SERVICE INSTRUCTION

Introduction of revised fuel pump assy. for ROTAX® Engine Type 912 i and 915 i (Series)

ATA System: 73-10-00 Fuel system

Fig. 1

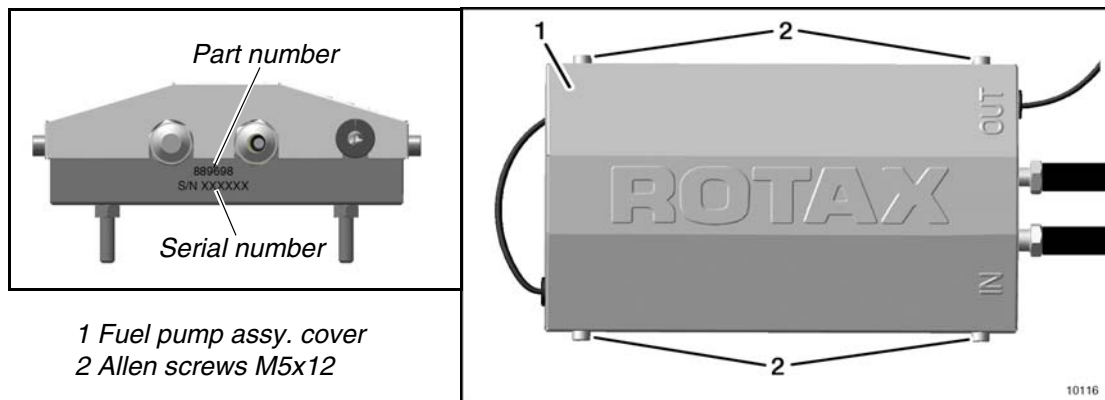
NOTE: Fuel pump assemblies with serial number (see [Fig. 1](#)) **lower** than listed in section 1.1 can be connected regardless of connector gasket revision (or color) present.

Check wiring harness connectors Fuel Pump 1/Fuel Pump A and Fuel Pump 2/Fuel Pump B to identify the color of the connector gaskets. In order to connect fuel pump assemblies listed in section 1.1, connector gasket part number 850620 (**orange** in color) must be present.

Fig. 2

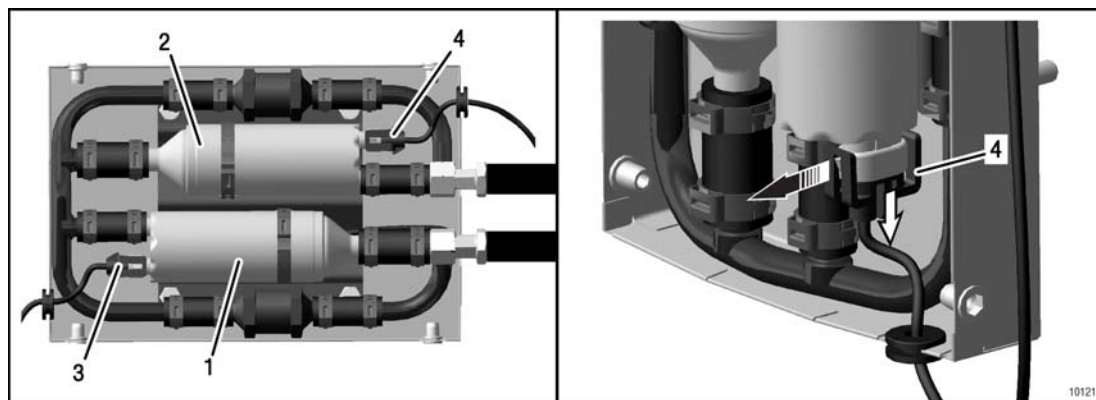
Step	Procedure
1	Remove the negative terminal of the battery.
2	Loosen 4 Allen screws M5x12 from the cover. Remove the cover.
3	Disconnect the wiring harness connectors from the fuel pumps (main, aux): - Lift the latches - See Fig. 2 - Unplug the wiring harness connectors
4	Check the color (orange must be present) of the wiring harness connector gasket. If wiring harness connector gaskets are of any other color, follow instructions in section 3.2 to replace with revised connector gaskets.

Fig. 3
Connectors gasket BLUE

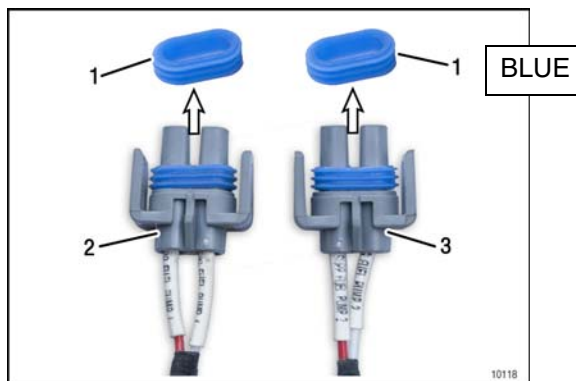
NOTE: Follows directions carefully to avoid damage to the connectors.
See Fig. 3.

Step	Procedure
5	Remove connector gasket (blue in color) from wiring harness connector Fuel Pump 1/Fuel Pump A and Fuel Pump 2/Fuel pump B .

Fig. 4
Connectors gasket ORANGE

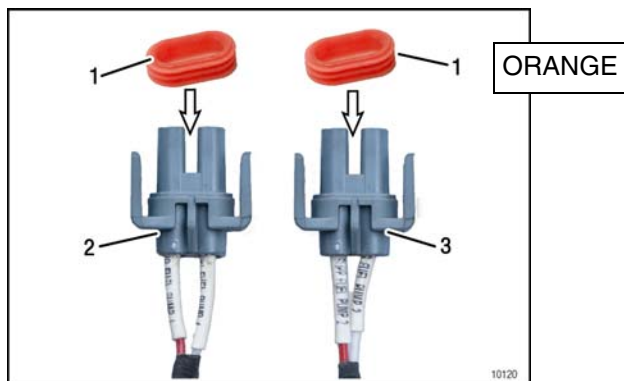
See Fig. 4

Step	Procedure
6	Place new connector gasket (orange in color) over wire connector housing.
